SB 07-03

Issued: 8/1/07 Revised: 8/27/07

BRS-600 Pick-up Collar Support Replacement

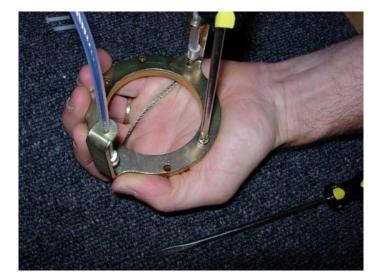
Some airplanes may exhibit a condition where upon activation of the rocket motor, the pick-up collar assembly may prematurely move off the launch tube and adversely affect rocket trajectory during deployment. This service Bulletin will correct this condition by installation of a new pick-up collar support and custom tension screws.

This Service Bulletin provides for the replacement of the pick-up collar support and screws.

- 1. Acquire necessary tools, equipment and supplies.
 - a. Phillips screwdriver
 - b. Flathead screwdriver
 - c. 1/4" socket with torque driver
- 2. Insert that safety flag in activation handle.
- 3. Remove and discard nylon tension screws securing pick-up collar assembly to launch tube...

4. Slide pick-up collar assembly off of rocket motor. Do not pull pick-up collar lanyards out of parachute canister. Perform work on top of parachute canister.

5. Remove screws securing existing pick-up collar support to pick-up collar.

6. Press retaining groove on pick-up collar support toward the rocket lanyard. Use fingers to pry rocket lanyard from opposite retaining groove and pivot the pick-up collar support until lanyard is disengaged from retaining grooves.

- 9. Position replacement pick-up collar support to upper side of pick-up collar.
 - WARNING: Position rocket lanyard around top outer diameter of pick-up collar support, NOT over top of rocket. Failure to comply will absolutely FAIL rocket deployment!

10. Position retaining groove of pick-up collar support to rocket lanyard. Pivot pick-up collar support until the rocket lanyard engages the opposite retaining groove.

11. Apply threadlock to screws removed previously from pick-up collar and attach new pick-up collar support to pick-up collar.
